Brisbane Central Business District Bicycle User Group

Please accept the below as our submission regarding the development on 17 Skyring Terrace, Teneriffe with the application number A006375195. As per standard CBD BUG practice our comments are limited to issues regarding people getting about via active transport and how they will be impacted by any project. Due to the binary nature of the Brisbane Development Application feedback, we currently **oppose** the development due to its poor provision for the missing section of the Riverwalk at the forementioned location.

Figure 3 – Development application – Landscape section

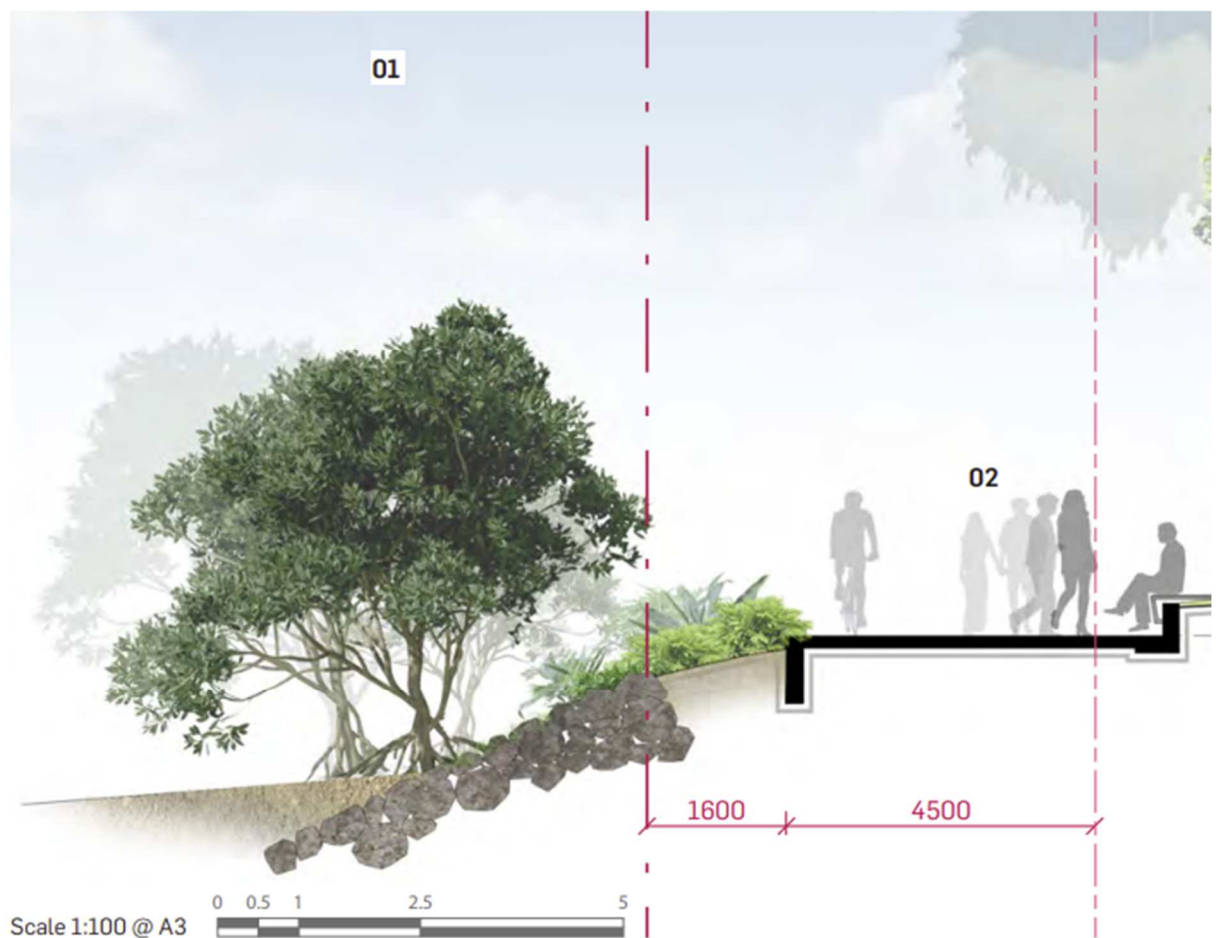
The CBD BUG is bitterly disappointed with the proposal as outlined in the documents supplied in the development application to Brisbane City Council. According to the Landscape plans submitted the riverwalk path will have a usable width of 4.5m (Figure 3). This is a contradiction of the Town Planning report that states "6m Riverwalk corridor" (Figure 4). Unless the developer intends people to walk on landscaping, to claim they have provided a "6m Riverwalk corridor" is a misrepresentation. An effective width of 4.5m would be even narrower than other recent developments (Macquarie One and Pier Waterfront) along this corridor that provided paths of approximately 5.5m.

Figure 7 – Urbis town planning reply

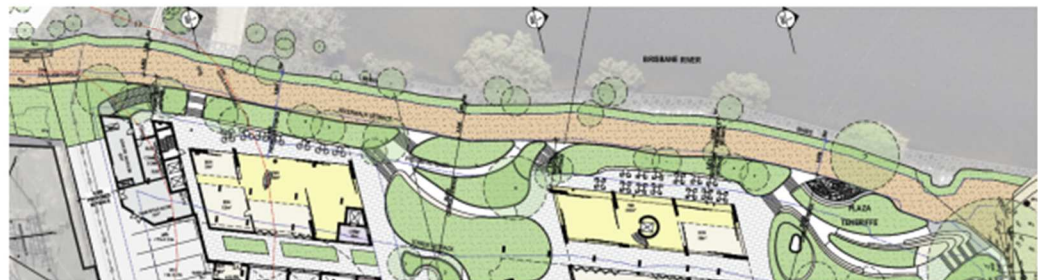
While we acknowledge the RFI response by Urbis (Figure 7) states the paved surface is now 6m wide the provided architectural plans contradict this statement. Architectural Sheets such as 2002 (rev 2) (Figure 8) continue to show a paved surface (brown hatch) of a 4.5m width and a landscaping strip of 1.5m (green hatch). To claim the 1.5m (green) is not landscaping but paved surface would not be in keeping with the rest of the drawing where the same hatch pattern is used to delineate landscaping. Considering the landscape plans have not been resubmitted with amendments it appears the development continues to provide a paved surface of a mere 4.5m. We also object to the BCC suggestion that within the "6m Riverwalk Corridor" that street furniture can be installed. A 6m Riverwalk should mean a minimum 6m of clear transport corridor width. A road

The architectural plans have been amended to demonstrate that the Riverfront land dedication is correctly calculated from the Brisbane River MHWS. Subsequential amendments have therefore been made to the **Riverwalk** to achieve a 6.1 metre wide corridor, 6 metres of which will be paved and 4.5 metres which will be unobstructed (refer to **Figure 20**). It is noted that a 100mm buffer strip is

Figure 8 – snippet of reissued architectural plan, Sheet SD2002, issue 2, BCC RFI, 22.11.2023

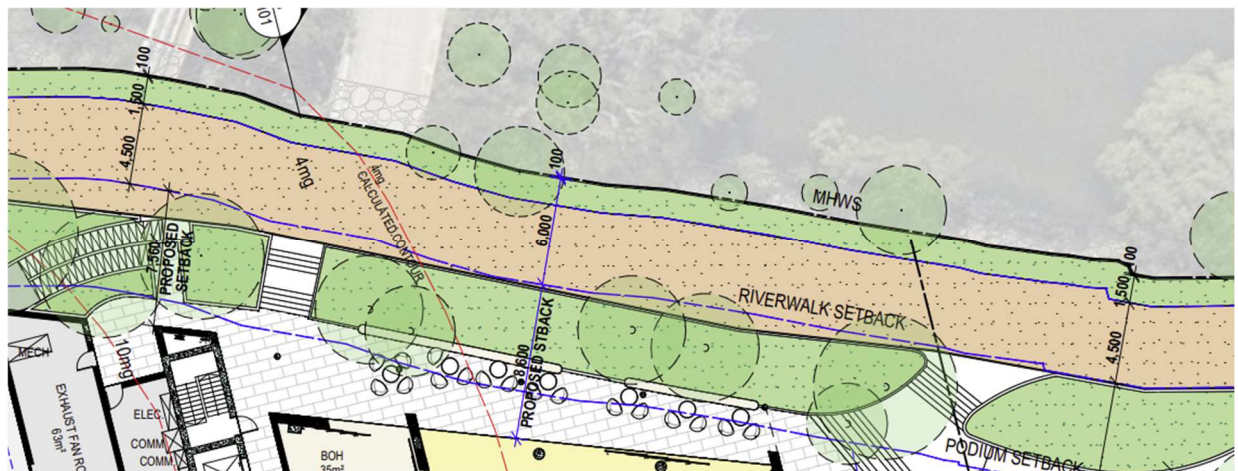
wouldn't have a light pole permitted within the paved surface and therefore neither should an active transport corridor.

The CBD BUG has noted that at the southern end of the proposed riverwalk there is an acute bend in the alignment of the corridor (Figure 8). Indeed when inspecting the drawings more closely it appears that little consideration has been applied to the riverwalk design by the architectural firm. It appears the architects in question have simply taken the boundary line and offset it 1.6m & 6.1m to provide the active transport corridor.

This clearly shows a lack of concern for the Development Application process and the Brisbane residents and visitors who will use this active transport infrastructure. As outlined in Austroads, where there is no physical constraints a path should be designed for a minimum operation speed of 35kmph. This has clearly not been taken into account looking at the drawing, as it appears these guidelines have been flatly ignored as the radii of the bends as featured in architectural plans could be as acute as a radius of 3m. Considering the development is fronting the river with minimum physical constraints there is no excuse for poor alignment in the proposed riverwalk. All bends in the Riverwalk corridor must comply with AustRoads guidelines.

As stated above the CBD BUG is disappointed with what is currently being proposed. We call on the council to reject the current proposal and require the developer to provide a minimum 6m clear path width (no obstructions including street furniture) riverwalk that is fully in compliance with TMR and AustRoads Guidelines. Patronage along this corridor will naturally continue to grow as more people move into the area and the “network effective” that will occur once this missing section is delivered.
